# Work Order ID 91933

Item Name: Energy Attenuating Floor Provisions

# DART SERVICE INSTRUCTION

TO AMEND INSTALLATION INSTRUCTIONS IIN-D350-689 REV. B  
AND INSTRUCTIONS FOR CONTINUED AIRWORTHINESS ICA-D350-689 REV. 1  
REF. TCCA STC: SH02-33  
REF. FAA STC: SR01620NY  
REF. EASA STC: EASA.IM.R.S.01453  
REF. TCA STC: 2005S03-09

**FIGURE 1: UPDATES TO FIGURE 21 (IIN-D350-689) AND 25-21 (ICA-D350-689)**

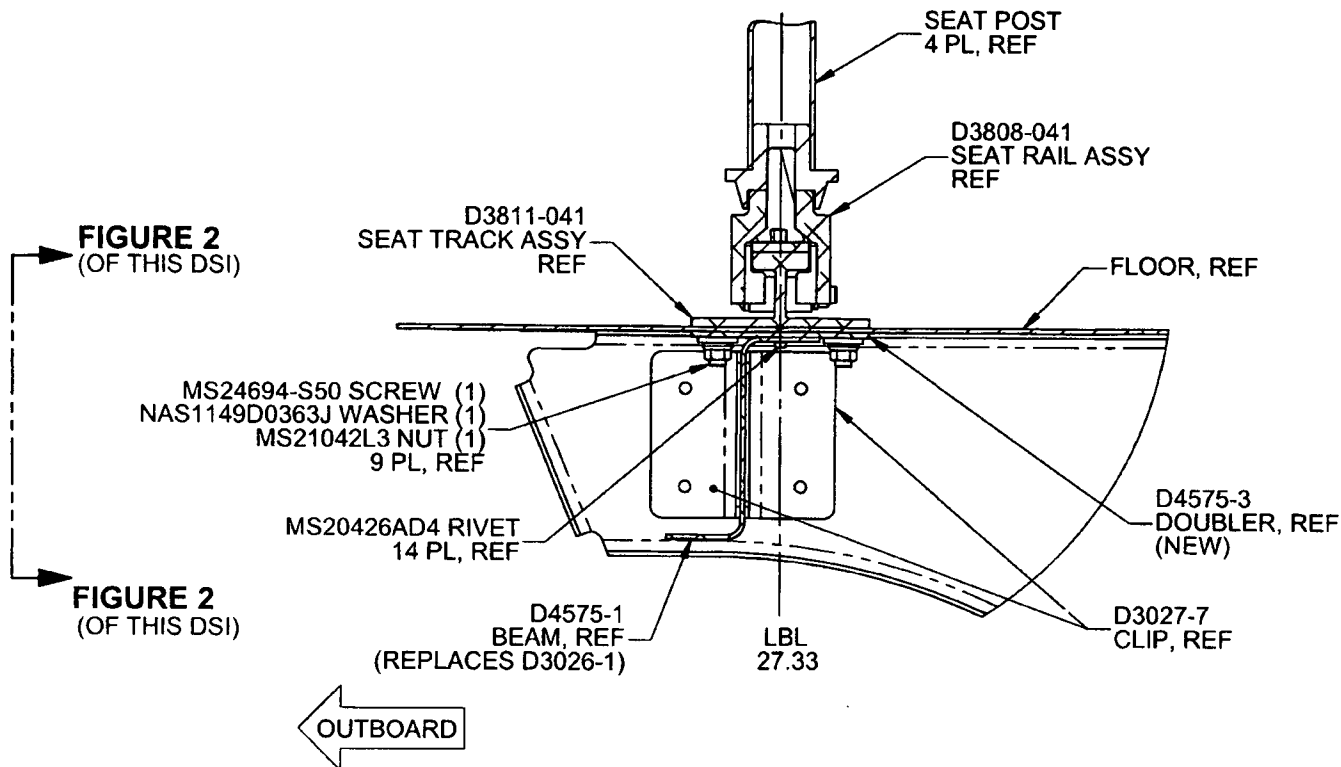
For D350-689-021/-023 Kits at CHG 005/004 and later, the D3026-1 Channel has been replaced with the D4575-1 Beam and D4575-3 Doubler and the D3234-3 Doubler has been removed. Consequently, the installation instructions for D350-689-021/-023 at CHG 005/004 are updated per Section 2.0 of this Service Instruction. The parts list update is shown in Section 4.0 of this Service Instruction. There is a negligible change to the weight and balance.

If there is an existing stringer at LBL 27.33, it will need to be removed from that location. Locate D4575-1 Beam and D4575-3 Doubler as shown in Figure 1 of this Service Instruction. Transfer drill existing holes from the aircraft floor to the D4575-1 Beam and D4575-3 Doubler. Ensure 1.0" to 1.5" rivet pitch and add additional holes if required. If there is no existing stringer, locate D4575-1 Beam and D4575-3 Doubler as shown in Figure 1 of this Service Instruction and drill Ø0.128" holes on a 1.0" to 1.5" pitch.

**FIGURE 2: RELIEFS ON D4575-1/-3**  
(ONLY D4575-1/-3 SHOWN FOR CLARITY)  
VIEW LOOKING INBOARD

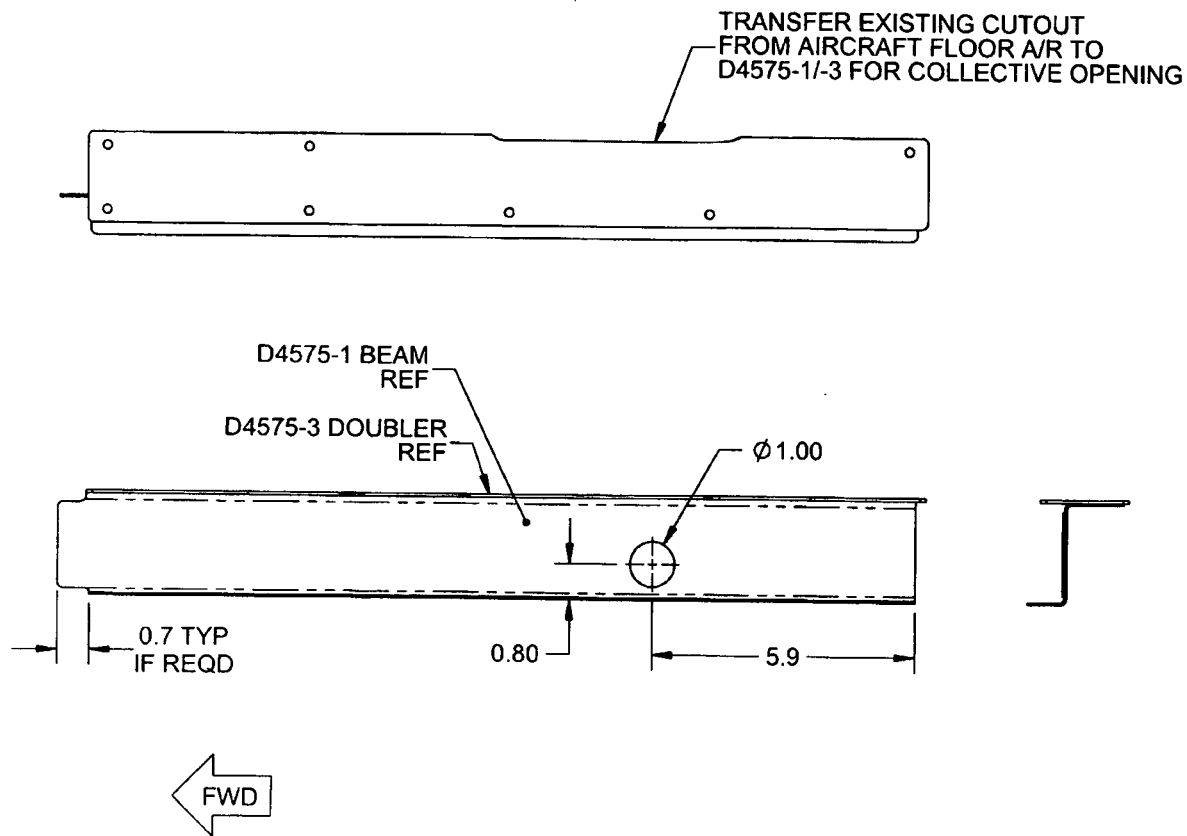
**Note:** Drill a Ø1.00" (Ø25.4 mm) hole in the D4575-1 Beam to clear extension tube of collective and cutout as required for clearance of collective opening and fwd bulkhead as shown in Figure 2 of this Service Instruction.
